Re: Docket # 15-BSTD-01**15-day 2016 Building Energy Efficiency Standards Section 130.1 (d) 2. D. iv.:
Incorrect change to Code Language****INTRODUCTION:**

A change in the specification to the required daylight level for Power reduction, (“Full Daylight Testing”), is *incorrect*.

Figure 13-116 – Performance of compliant switching controls - total light (daylight + electric light) versus daylight

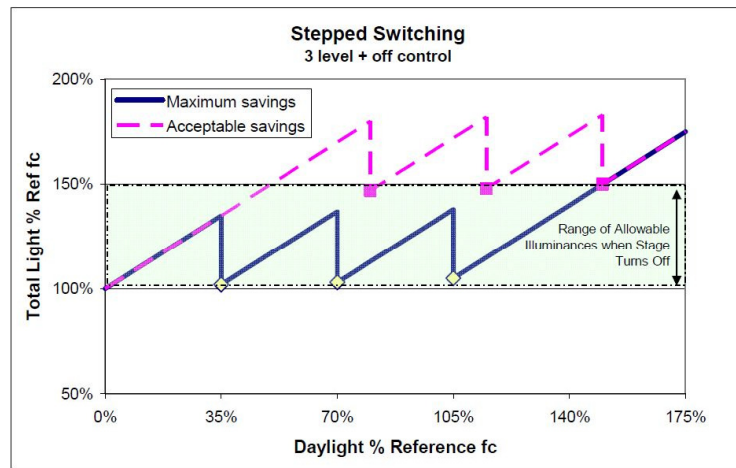
So ... the combined illuminance measured at the reference location is *allowed* to exceed 150% of Reference Illumination before even one stage of lighting steps off. This renders a Combined Illumination level *useless* for power reduction testing in this sort of system. Also note: the “No Daylight” Electric Illuminance in a stepped system will typically be “Full output”.

The illustration from chapter 13 of the Nonresidential Compliance Manual, (next page), shows this graphically:

While many, many things in the *text* of the 2013 Nonresidential Compliance Manual are incorrect, the *illustrations* involving Automatic Daylight Controls all appear to be correct.

It is recommended that the change to Section 130.1 (d) 2. D. iv. Be reversed.
